Author Reply to Referee 1_Fourth Round

Theory of the generalized chloride mass balance method for recharge estimation in groundwater basins characterised by point and diffuse recharge

By N. Somaratne and K. R. J. Smettem

Anonymous Referee #1

Figure 1. Uley south link to Big Swamp (from Zulfic et al, 2007).

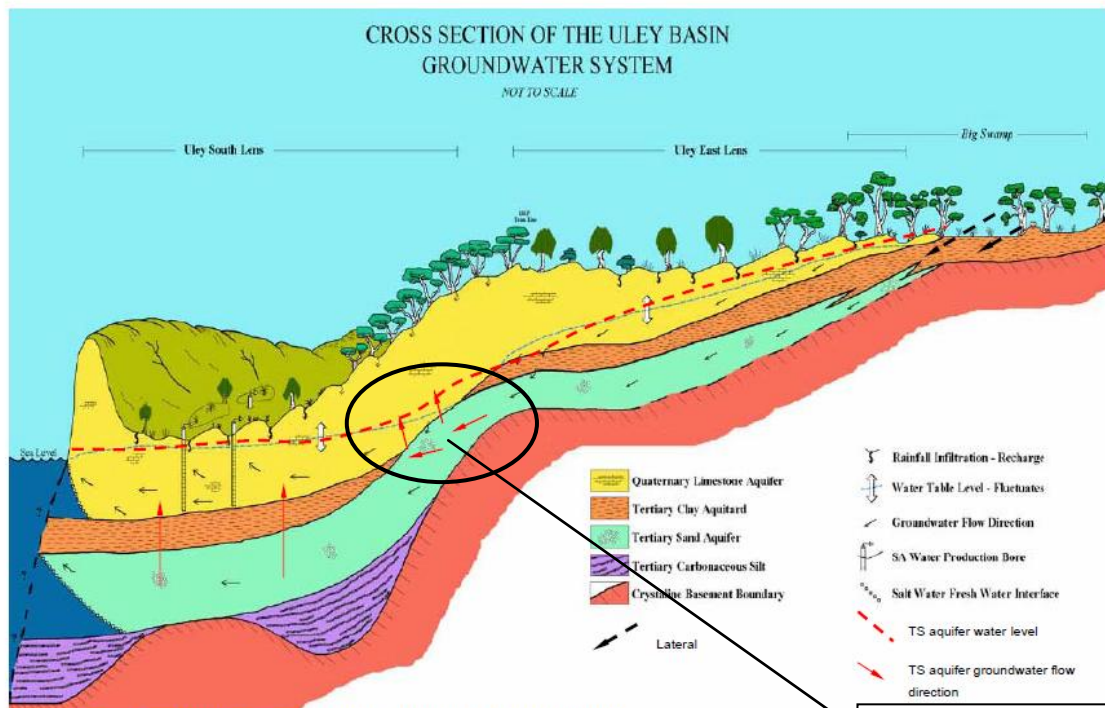
Referee 1-C1: For Uley South, the simple mixing calculation (Cl value for diffuse only recharge is 147 mg/L and diffuse-only recharge is 56 mm/year; Cl for point recharge is 14.2 mg/L and point recharge is 75 mm/year), deemed "interesting" by the authors, is rather an irrefutable mass balance for the water entering Uley South. It is completely inconceivable that the dozens of Cl measurements (none of which are somehow remarkably monitoring at the watertable as indicated by the author's "Why the Conventional CMB Fails in Karst") can be avoiding this huge influx of freshwater (75 mm/yr of Cl 14.2 mg/L) that the authors are suggesting. The piezometers mostly go to the bottom of the unconfined aquifer and there are dozens of them. None of them find water of the average mixed portion (71 mg/L), or fresher. Not a single one. There is no hope that karst passageways are magically weaving their way around the piezometers. If there is 75 mm/y of 14.2 mg/L and 56 mm/yr of 147 mg/L, then half of the aquifer contains water of 71 mg/L or less, apparently. Yet, the lowest Cl is >100 mg/L. The authors have created recharge that they can't defend from the perspective of the aquifer's Cl values. Mass balance is violated, and it has nothing to do with the monitoring strategy, it occurs because the authors eliminate salt mass flux through sinkholes. It is incomprehensible that something so obvious can continue to be a sticking point for the authors.

Uley South limestone aquifer water is derived from three main sources: diffuse recharge from the basin, point recharge through sinkholes, and Tertiary Sand water with high salinity/chloride entering the limestone aquifer as a result of limestone aquifer's depth coincident with Tertiary Sand aquifer in the area where Tertiary clay aquitard is not present.

Please refer to the Page 382, Fig. 1 of the manuscript. In Figure 1, the Tertiary Clay absent area (about 5 km in length) at the landward boundary of the central basin, is the area where Tertiary Sand water enters into the limestone aquifer. The high salinity water originates from Big Swamp, 18 km north-east of Uley South and flows through the Tertiary Sand (on its path way mixing with other low salinity waters) and enters Uley South where Tertiary Clay is absent (see Figure 1 below).

This higher salinity water, once it enters the Uley South along its 5 km stretch, mixes with low salinity Limestone water and flows through the entire Central Part of the basin (see Figure 2 below). The nested bores ULE109 and ULE197; and ULE184 and ULE 185 are located approximately 2 km down gradient from the Tertiary Clay absent area and up-gradient to the all production wells. As can be seen from Figure 2,

Figure 3. Uley South typical sinkhole-Runoff terminates in a sink hole

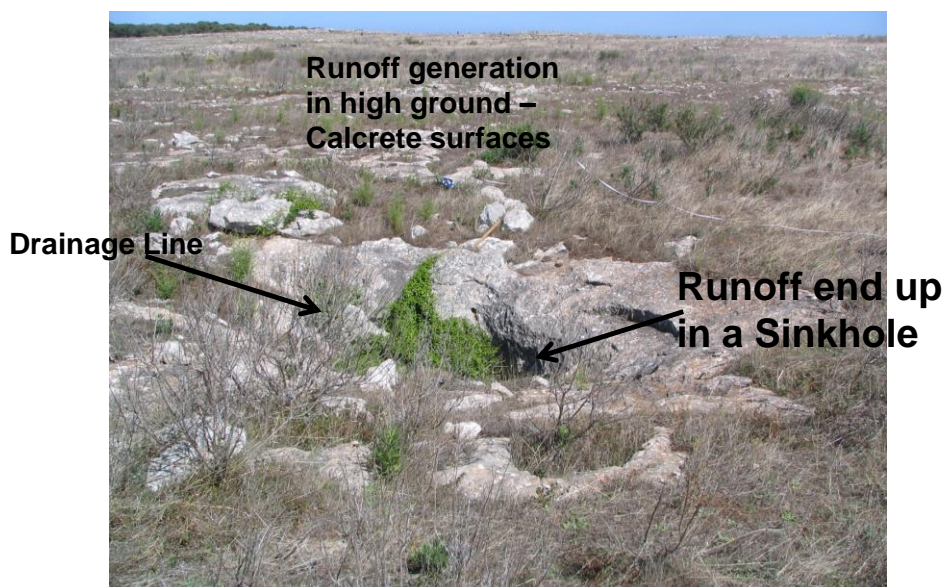
Referee 1-C2: The method is NOT a generalised CI method. It requires an estimation of catchment Runoff, which according to the authors ALL ends up as recharge. This is a ridiculous notion. All catchment runoff can never become sinkhole recharge, unless the catchment is, literally, a bathtub. What's more, the method requires a characterisation of diffuse recharge CI and sinkhole CI, neither of which is obtained for the cases they present. In Uley South, there is no clay between the upper and lower aquifers in places - mixing occurs between upper and lower aquifers, and the lower aquifer is connected to basins to the north. There is simply no way that their diffuse CI values can be taken from CI measurements around the basin's perimeter. Without unsaturated zone CI values, the method is entirely indefensible, and therefore impractical without considerably more measurements. Runoff (becoming sinkhole recharge) and diffuse recharge CI are beyond the capacity of the authors to obtain, and hence they have invented values that, intentionally in my view, produce recharge to Uley South that is excessive for the purposes of commercial gain.

The findings regarding calcrete surface generated runoff and that flow to sinkholes, as well as calcrete surface contributes to diffuse recharge, is supported by a presentation made by the first author two years ago to a group of local hydrogeologists. We present the relevant slide below, which is self explanatory. This photo shows the typical landscape of the Uley South basin.”

Obviously, not all runoff becomes sinkhole recharge. A proportion of the runoff becomes diffuse recharge and a portion is lost to ET. It is the issue of how the rainfall-runoff models are parameterised, including the setting up of initial and continuous losses. For the three case studies, the following descriptions are given in Somaratne et al (2013) and summarised in this paper.

Uley South is a topographically closed basin. Runoff is highly ephemeral, occurring only after moderate to high intensity rainfall and persisting only tens to hundreds of meters before entering a sinkhole (Evans, 1997; Harrington et al., 2006; Ordens et al., 2012)- see page 312, Lines 15-17. As such, the assumption of total runoff becoming recharge is reasonable.
